ASERCOM/EPEE comments on the 2nd interim report of the professional refrigeration review study – detailed paper

ASERCOM and EPEE have brought together a Joint Industry Expert Group (JIEG) for the revision of ecodesign requirements under ENTR Lot 1 (professional refrigeration), to assess the second interim professional refrigeration report from the Commission, based on a significant number of condensing units and process chillers performance data.

2. The consultants propose overly ambitious MEPS (column: EC proposal SEPRmin).

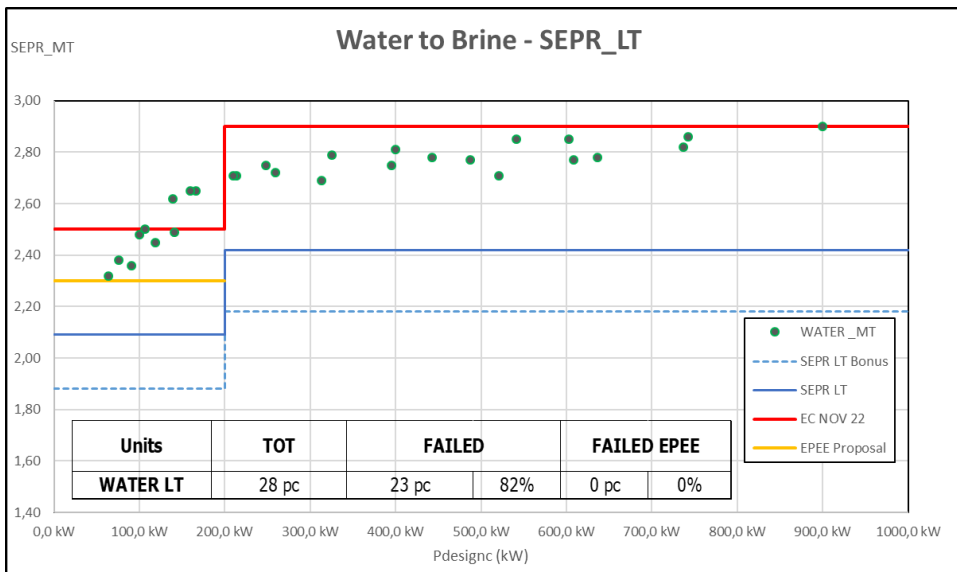
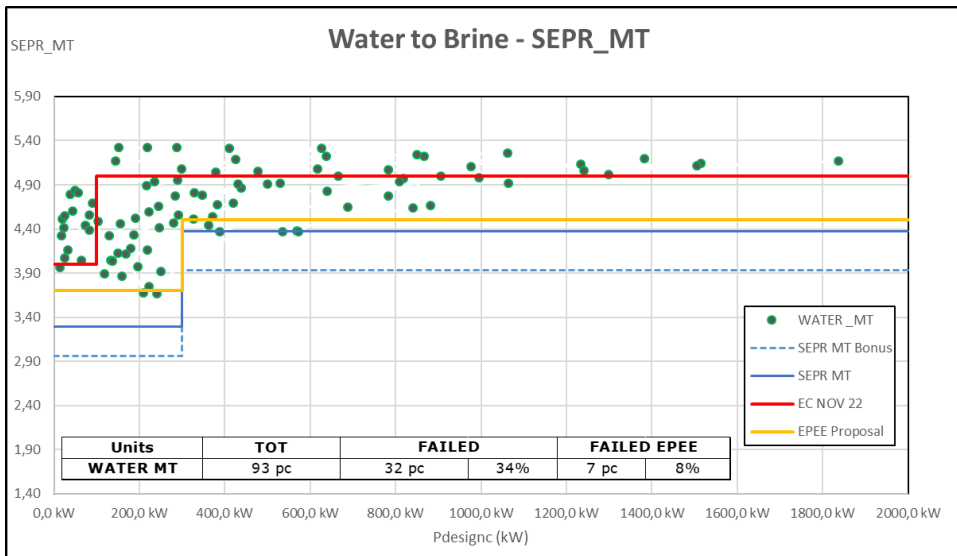
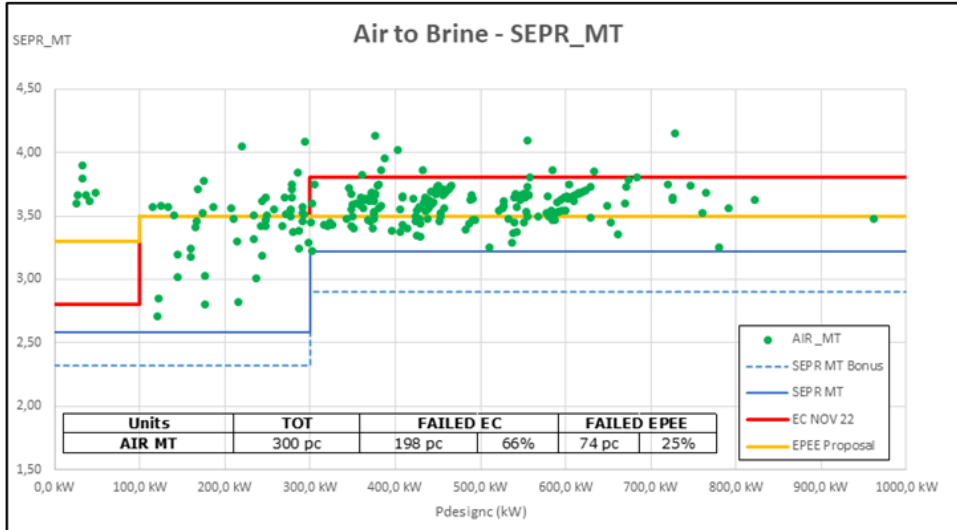
ASERCOM/EPEE view the proposed MEPS (the changes are calculated based on the current MEPS with applied GWP bonus) as too ambitious and unattainable.

Our own research on 483 process chillers (marketed by **ASERCOM/EPEE** member companies) showed that 61% of total chillers, 69% of low temperature air/brine chillers and 66% of air-cooled MT chillers would be eliminated from the market if the EC proposal is applied.

The water/brine MT sector shows a 34% failure rate, while the water/brine LT units are almost completely removed from the market with 82% failure. The details of this investigation are shown in the graphs below.

For water-based LT chillers, the current EC proposal brings the market to a halt. This is evident for units >200 kW where almost all units fail. An internal study showed a market size of not much more than 100 units/year in the EU. In addition, these units are usually highly customised to the needs of the application. Therefore, we propose excluding water-based LT chillers >200kW from the Ecodesign scope.

Technical issues (e.g. compressor efficiency, shell, and tube vs plate heat exchangers) create physical limitations for setting MEPS on SEPR for low-temperature to the water-based low-temperature chillers ≤200kW, where we recommend a maximum value of 2,3.

We propose the changes in red compared to the consultant's proposal, as you can see below.

Process chillers	CAPACITY range		Curr SEPR _{min}	SEPR _{min} EC	SEPR _{min} EPEE	Change
Medium operating temperature	Air / Water	0	≤ 300 kW	2,32			
	Air / Water	0	≤ 100 kW	2,32	2,80	3,3	42%
	Air / Water	100 kW	< 300 kW	2,32	3,50	3,5	51%
	Air / Water	> 300 kW	≤ 2000 kW	2,90	3,80	3,5	21%
Low operating temperature	Air / Water	0	≤ 200 kW	1,53	1,87	1,8	18%
	Air / Water	> 200 kW	≤ 2000 kW	1,66	2,02	1,95	18%
Medium operating temperature	Water- Brine / Water	0	≤ 300 kW	2,96	4,00	3,7	25%
	Water- Brine / Water	> 300 kW	≤ 2000 kW	3,93	5,00	4,5	14%
Low operating temperature	Water- Brine / Water	0	≤ 200 kW	1,88	2,50	2,3	22%
	Water- Brine / Water	> 200 kW	≤ 2000 kW	2,18	2,90

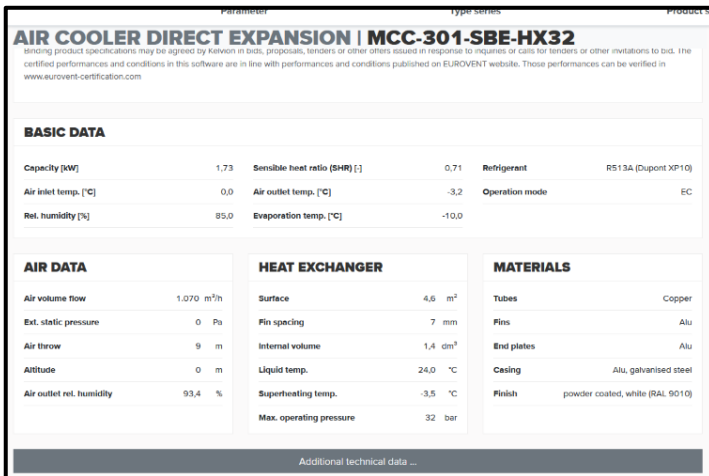
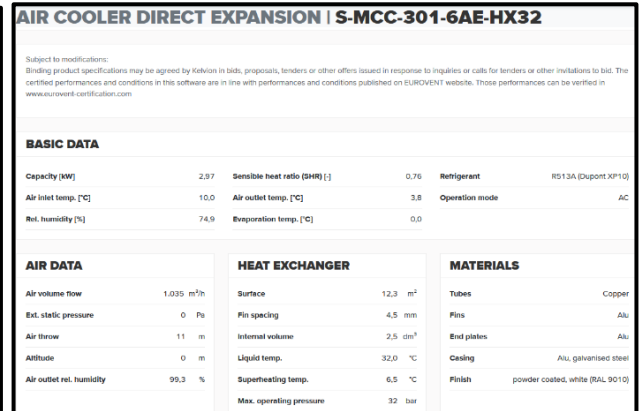
Comment: The same CU with different application 50% higher capacity and COP. Yet the evaporator surface must be tripled to reach this (from 4.6 to 12.3 m²)!
